**49 CFR Part 571**

**Federal Motor Vehicle Safety Standards; Lamps, Reflective Devices and Associated Equipment**

**ACTION:** Final rule.

**FIGURE 31 - TRACTOR CONSPICUITY TREATMENT EXAMPLE**

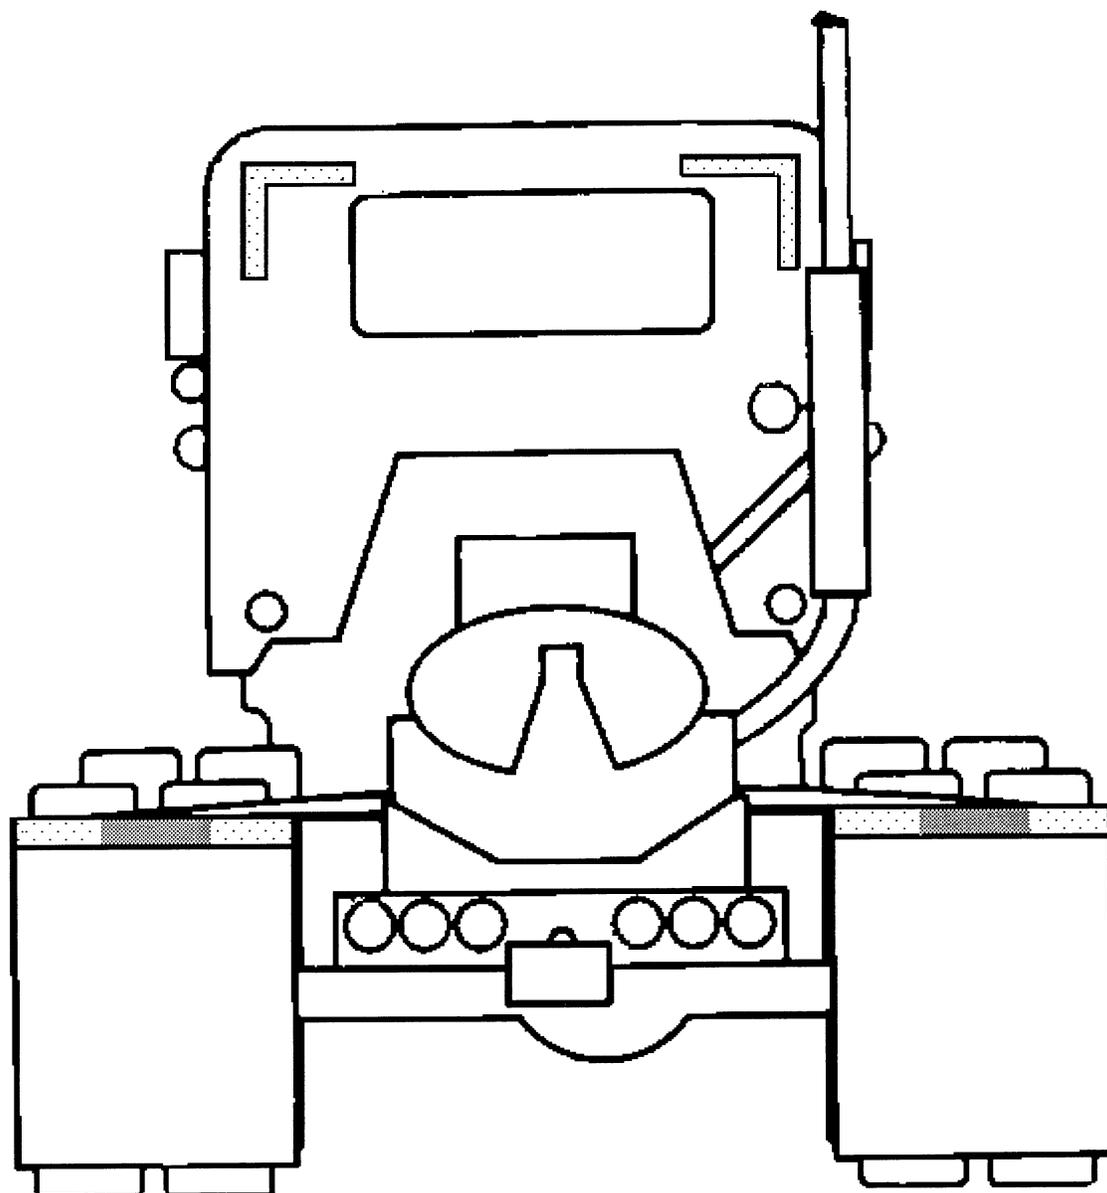
As with large trailers, two strips of white material 300 mm in length were proposed for application horizontally and vertically to the right and left upper rear contours of the body (as shown in Figure 31), as close to the top of the body and as far apart as practicable. Relocation of the material would be

The second part of the proposed conspicuity treatment was illustrated in the NPRM as a pair of inverted "L" 's of white conspicuity material to mark the upper contour of the cab. This element is identical in shape and purpose to the upper conspicuity marking of trailers. The purpose of the upper material is to create a two-dimensional image to improve the judgement of distance and closing speed on the part of drivers approaching from a distance. On truck tractors, which are not required to have rear clearance and identification lamps,

The previously discussed comments of ATA, TMA and the vehicle manufacturers regarding the possibility of a false indication of the rear of the vehicle as a result of reflective material on the lower cab and the lack of space on the rear of the cab to mount material were also directed toward the upper material. Mack and ATA provided pictures of vehicles to illustrate application difficulties. Navistar and TMA commented that the addition of non-OEM headboards, sleeper compartments and tool boxes would obscure the material, and they noted that even if the material were visible viewed from directly behind, as specified in the NPRM, it could be obscured viewed from a small angle. TMA asked for clarification regarding the avoidance of discontinuous surfaces, whether the vertical and horizontal reflector strips must intersect, and whether aerodynamic roof fairings are included in the cab contour.

The most common obstructions at the upper cab corners are exhaust stacks. The NPRM illustrated the right upper marking moved inboard to clear an exhaust stack, and the proposed regulation permitted manufacturers to move the marking on the opposite side to achieve a symmetrical appearance, if desired. The commenters supplied photographs of various truck tractor configurations illustrating possible obstructions. The most problematic cases for upper treatment were those featuring large rear windows with limited space between the rear window frame and large dual exhaust stacks on each side of the window. However, even these designs appeared to have enough space between the window and the stack obstruction for a one-inch wide reflex reflector bar if not a 2-inch strip of sheeting material. Also, the material may be attached to the edge of the window itself if the window is so large as to occupy all the practicable space for an upper treatment. However, limited obstructions such as fairing support

(b) Element 2: Two pairs of white strips of sheeting, each pair consisting of strips 300 mm long, applied as horizontally and vertically as practicable, to the right and left upper contours of the body, as close to the top of the body and as far apart as practicable. No more than 25 percent of their cumulative area may be obscured

by vehicle equipment as determined in a rear orthogonal view. If one pair must be relocated to avoid obscuration by vehicle equipment, the other pair may be relocated in order to be mounted symmetrically.
